PCN# 20140506000

Replace Crystal with Oscillator, Correct VPP on MitySOM-335X Family System on Modules

Title: Replace Crystal with Oscillator, Correct VPP

Figure 4 VPP Corrected

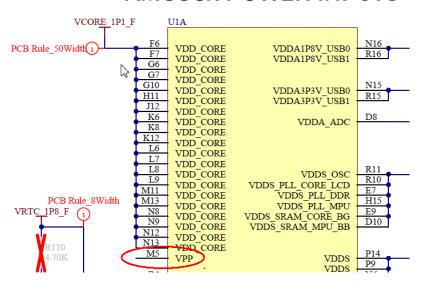
AM335x Processor VPP pin (M5) changed from 1.1V pull up to no-connect. See Figure 3 and Figure 4. See Table 1 for models/ part numbers affected.

Figure 3 VPP Not Corrected

Per TI datasheet, this should be no-connect for functional operation.
